## Draft Responses to Comments

Comment Letter HH

RE: WIND ENERGY ZONING ORDINANCE AND GENERAL PLAN AMENDMENT  
ENVIRONMENTAL IMPACT REPORT; POD10-007, LOG NO. 09-00-003; SCH NO.  
2010091030

Enclosure 1

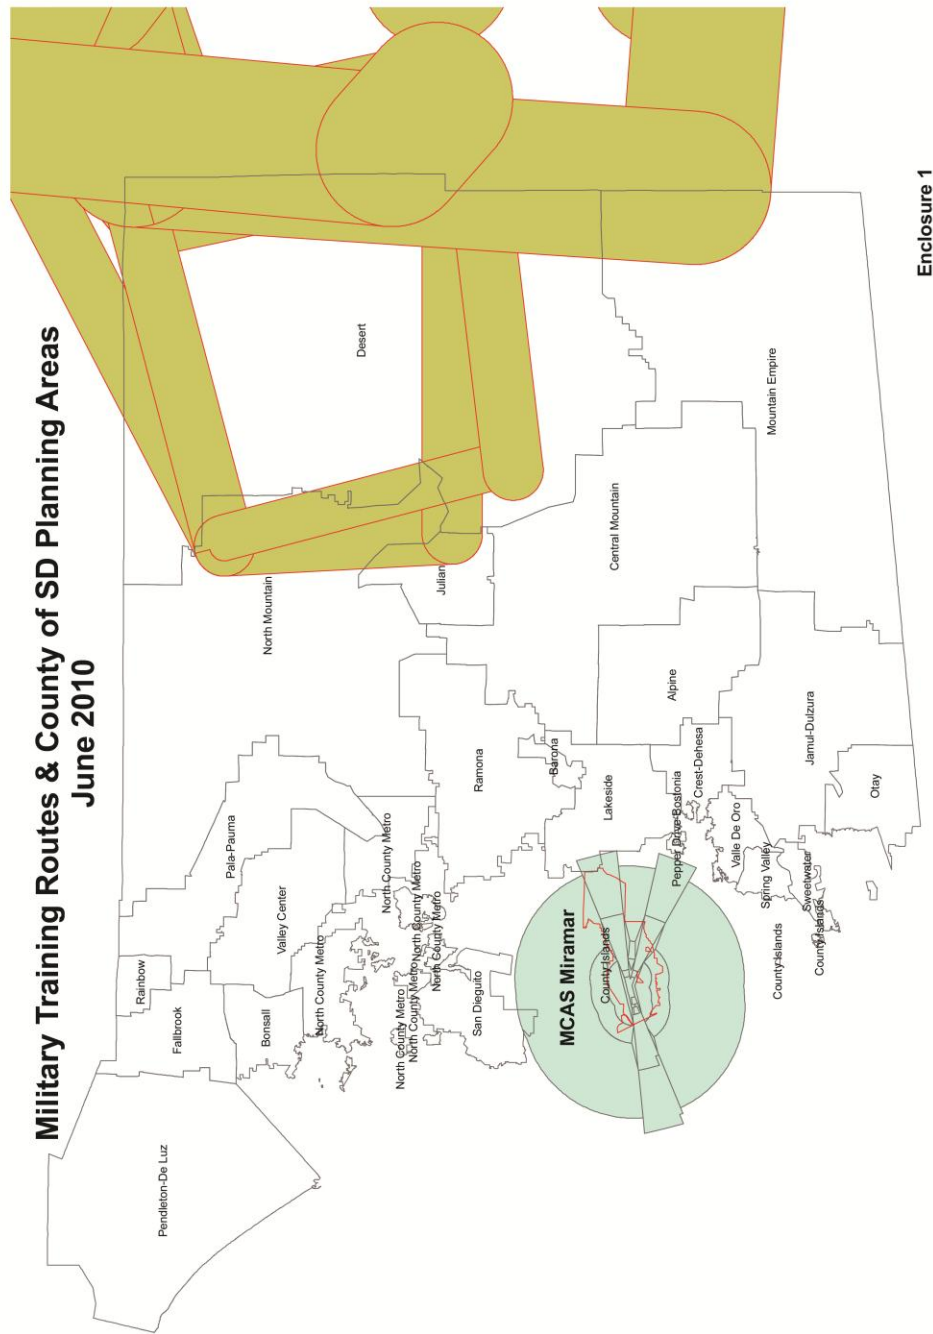
After reviewing the document, our primary concern deals with the construction of large and small wind turbines under or in the vicinity of a Military Training Route (MTR). Wind turbines are a physical obstruction that can be a source of radar interference for military aircraft. Additionally, while located many miles away from a military installation, these structures can restrict low-level aircraft flights and in turn jeopardize the purpose of military installations and the integrity of the airspace. To ensure that military operations are not restricted in East San Diego County, we recommend that language be included in the revised ordinance that states that the military should be consulted when single and/or multiple large or small wind turbines are proposed for construction under any MTRs. This will ensure safety of flight for military aircraft, and allow the County of San Diego and project proponent to receive feedback directly from a prominent aviation user of airspace in that region. To assist with our recommendation, we have included a map showing MTRs in San Diego County (Enclosure (1)).

- HH-1** This comment is introductory in nature and does not raise a significant environmental issue for which a response is required.
- HH-2** The County acknowledges and appreciates this comment. In response to this comment, the proposed ordinance has been revised to include a provision that will require notification to the military when small turbines are proposed in Military Training Routes. Administrative processing procedures are already in place to ensure the military is consulted on all large turbine projects during the discretionary review process. Finally, the County has coordinated with David Hulse, Community Plans and Liaison officer, NAVFAC Southwest to ensure the County's GIS Database includes all relevant Military Training Route data.
